Well Name: STERLING SILVER 34 FED	Well Location: T23S / R31E / SEC 34 / SENW / 32.2629346 / -103.7688229	County or Parish/State: EDDY / NM
Well Number: 4	Type of Well: OIL WELL	Allottee or Tribe Name:
Lease Number: NMNM43744	Unit or CA Name:	Unit or CA Number:
US Well Number: 3001531092	Operator: OXY USA INCORPORATED

Notice of Intent

Type of Submission: Notice of Intent	Type of Action: Plug and Abandonment
Date Sundry Submitted: 10/08/2025	Time Sundry Submitted: 06:32
Date proposed operation will begin: 11/08/2025

NOI TO PERMANENTLY ABANDON THIS WELL VIA CEMENT PLUGGING.

Proposed Wellbore
STERLING SILVER 34 004

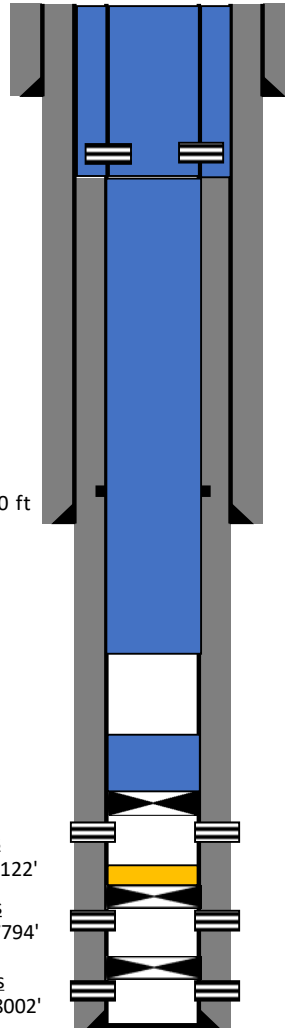
OK AS PROPOSEDFORMATION TOPS

APPROVED*By Keith Immatty at 11:30 am, Dec 14, 2025*HISTORIC CIBP AND RBP ON FILE

Created By	Condition	Condition Date
gcordero	Spot 15 sacks cement 5300' - 5200' - T Cherry Canyon	12/24/2025
gcordero	Adhere to current Plug & Abandon (P&A) Conditions Of Approvals (COA).	12/24/2025
gcordero	A Cement Bond Log (CBL) is required to be submitted to electronic permitting.	12/24/2025
gcordero	Submit Cement Bond Logs (CBL) prior to submittal of C-103P.	12/24/2025
